## ORDINANCE NO. 5322

AN ORDINANCE to amend and reordain the Master Plan of the City of Alexandria, Virginia, by adopting and incorporating therein the amendment heretofore approved by city council to the Potomac West Small Area Plan chapter of such master plan through the Oakville Triangle & Route 1 West Corridor and Vision Plan Overlay as Master Plan Amendment No. 2020-00003 and no other amendments, and to repeal all provisions of the said master plan as may be inconsistent with such amendment.

## **Oakville Plan updates as amended:**

## Figures 3 & 18: Illustrative Plan

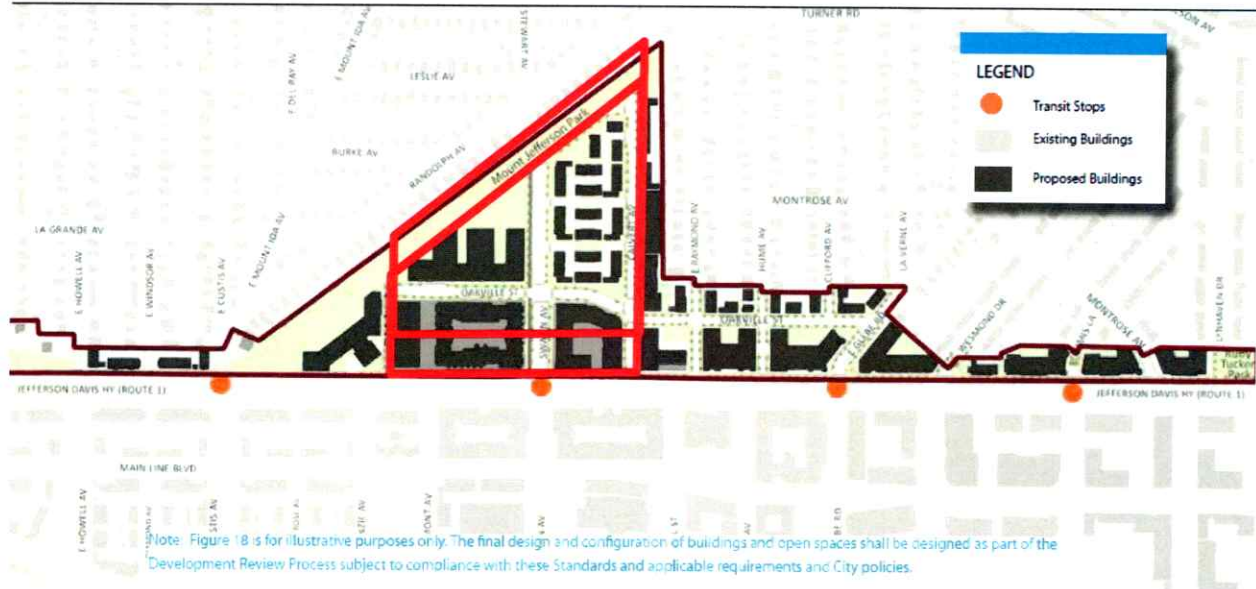
- Figure 3 & 18: Illustrative Plan
- Figure 7: Oakville Triangle District
- Figure 19: Framework Streets
- Figure 25: Land Uses
- Figure 27: Maximum Building Heights
- Figure 28: Minimum Building Heights
- Figure 29: Open Spaces (Public, Ground level and Roof-top)
- Figure 30: Open Spaces adjacent to Mount Jefferson Park
- Figure 41: Ground Floor Uses: Retail, and Maker Spaces
- Figure 47: New and Reconfigured Streets
- Street Cross-Sections: Pages 117 - 125
- P.24: Transportation Improvements Table
- Chart 1: Public Benefits Phasing
- Chart 2: Development Summary Table

Figure 7: Oakville Triangle District

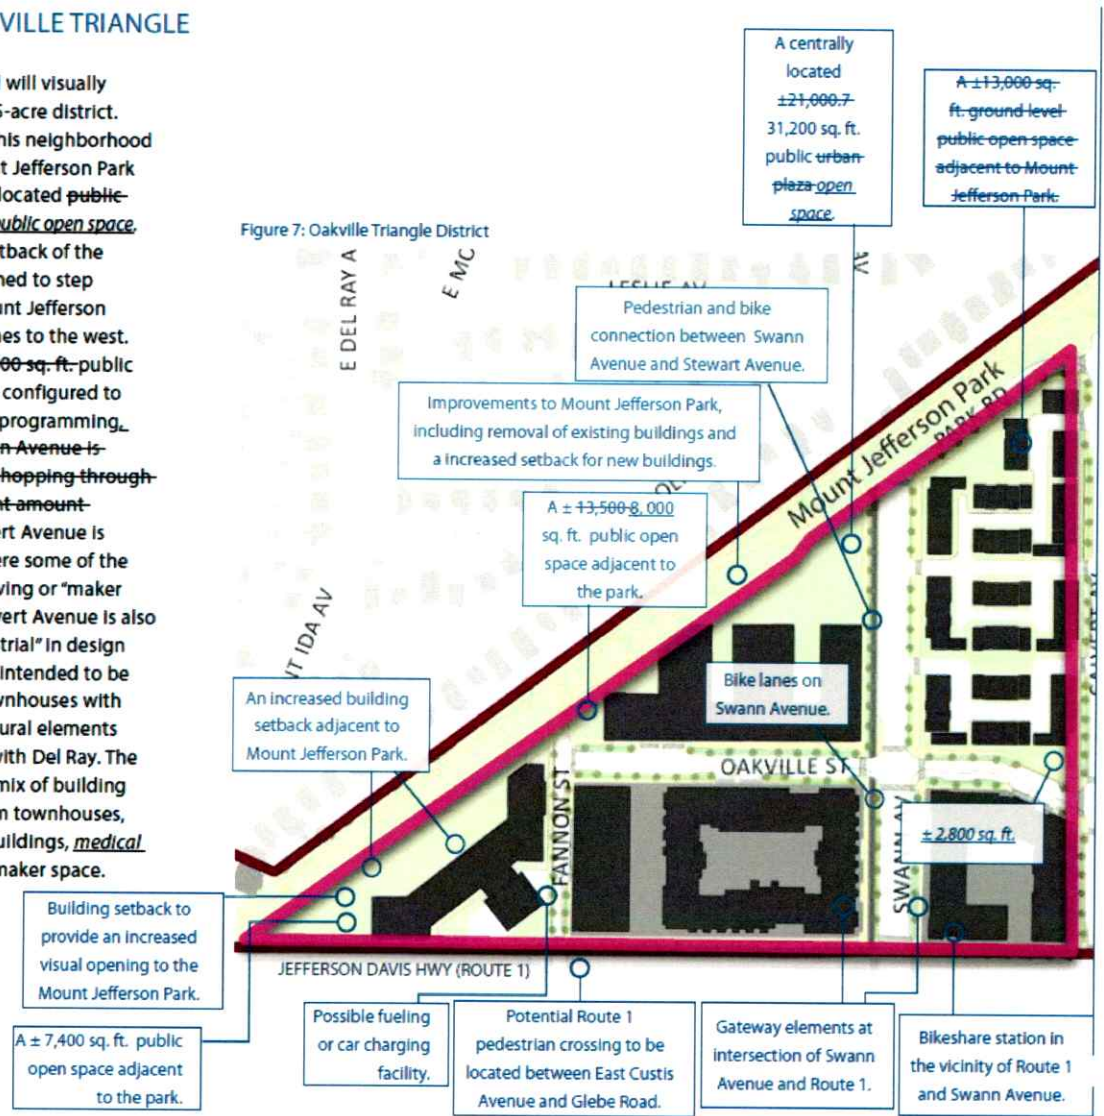
- Amend the column of text, as follows: Establishing the street grid will visually unify this approximately 15-acre district. The defining elements of this neighborhood will be the adjoining Mount Jefferson Park frontage and the centrally located ± 31,200 sq. ft. public open space. The building height and setback of the buildings have been designed to step

down to the adjoining Mount Jefferson Park and single-family homes to the west. The centrally located public open space will need to be configured to accommodate events, programming, and social gatherings. Calvert Avenue is intended to be an area where some of the existing neighborhood-serving or “maker uses” could be located. Calvert Avenue is also intended to be more “industrial” in design and character. Park Road is intended to be smaller scale 30’-45’ tall townhouses with front porches and architectural elements and materials compatible with Del Ray. The district is intended to be a mix of building types and uses ranging from townhouses, multi-family, office, hotel buildings, medical care facility, and retail and maker space.

Establishing the street grid will visually unify this approximately 15-acre district. The defining elements of this neighborhood will be the adjoining Mount Jefferson Park frontage and the centrally located public urban plaza  $\pm 31,200$  sq. ft. public open space. The building height and setback of the buildings have been designed to step down to the adjoining Mount Jefferson Park and single-family homes to the west. The centrally located  $\pm 21,000$  sq. ft. public open space will need to be configured to accommodate events, and programming, and social gatherings. Swann Avenue is intended to provide retail shopping through the provision of a significant amount of ground floor retail. Calvert Avenue is intended to be an area where some of the existing neighborhood-serving or "maker uses" could be located. Calvert Avenue is also intended to be more "industrial" in design and character. Park Road is intended to be smaller scale 30'-45' tall townhouses with front porches and architectural elements and materials compatible with Del Ray. The district is intended to be a mix of building types and uses ranging from townhouses, multi-family, office, hotel buildings, medical care facility, and retail and maker space.

Figure 41: Ground Floor Uses: Primary, Secondary Retail, and Maker Spaces

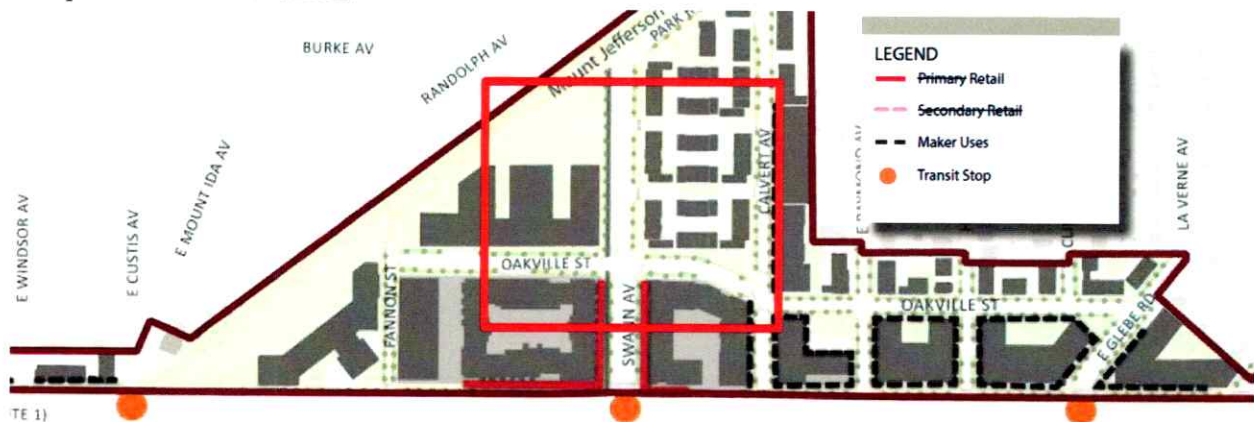
- Amend the title of Figure 41, as follows: Figure 41: Ground Floor Uses: Retail, and Maker Spaces

p.117 Fannon Street (Interim) (Adopted 2020 Amendment)

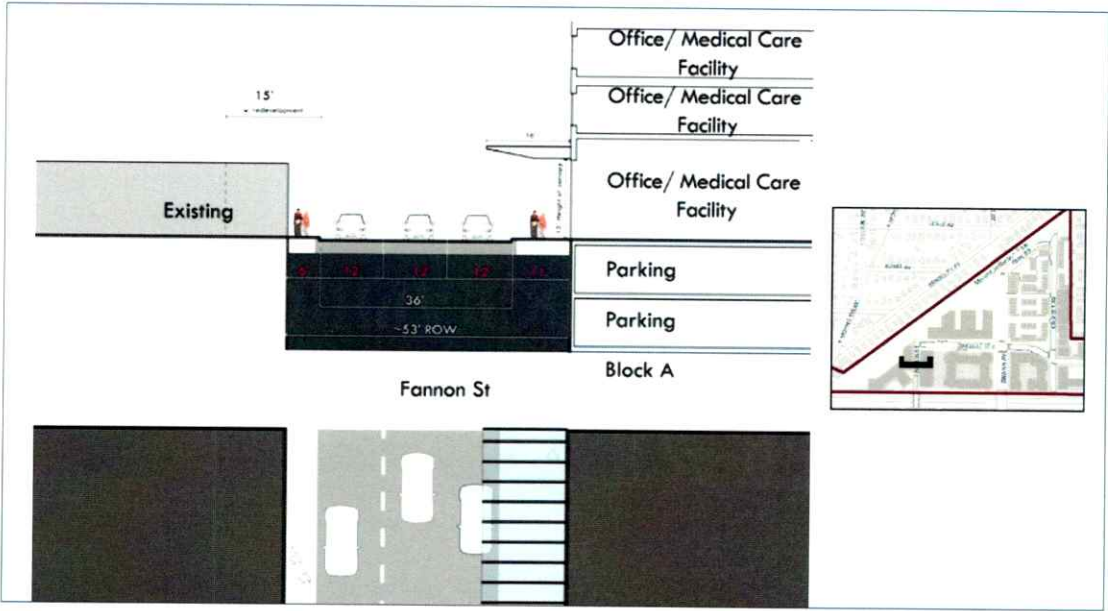
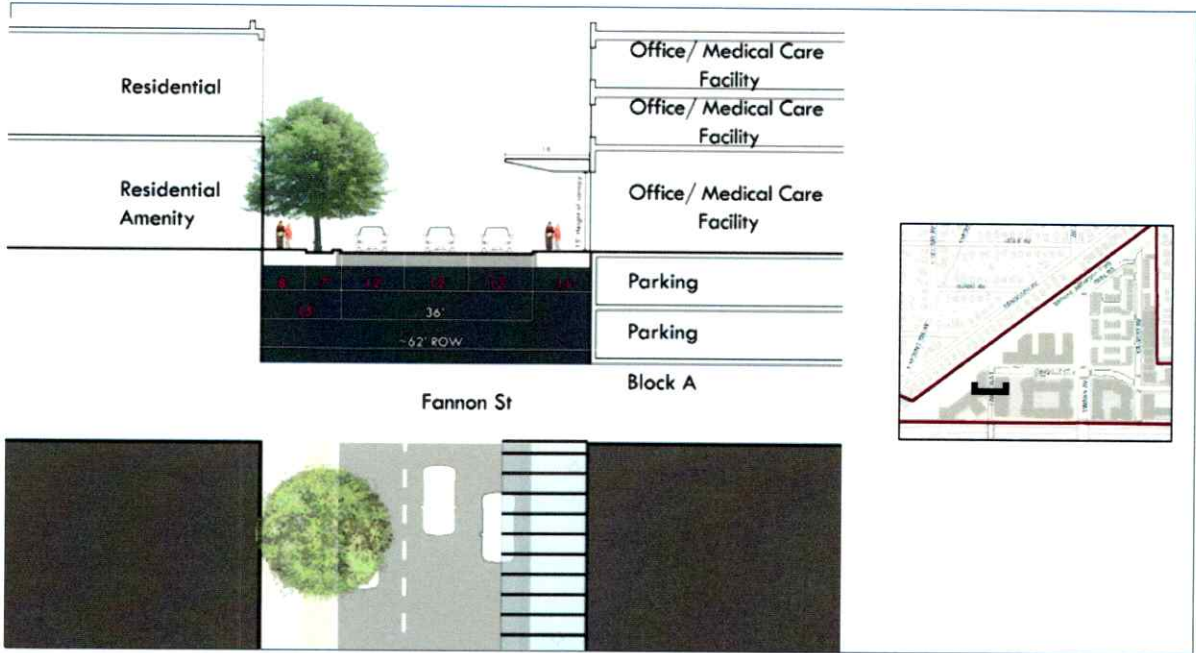
- Amend Recommendation 1.13, as follows: A pedestrian and bike connection between Swann Avenue and Stewart Avenue to provide connectivity between the neighborhoods and the future Potomac Yard Metrorail station.
- An additional signalized crossing across Route 1 at Fannon Street, including pedestrian and intersection improvements, to improve pedestrian access between Oakville Triangle and Del Ray/Lynhaven and the Potomac Yard Metrorail station and provide efficient access to the medical care facility.

- Add as a new bullet: Installation of traffic signal, pedestrian, and intersection improvements at Fannon Street and Route 1.
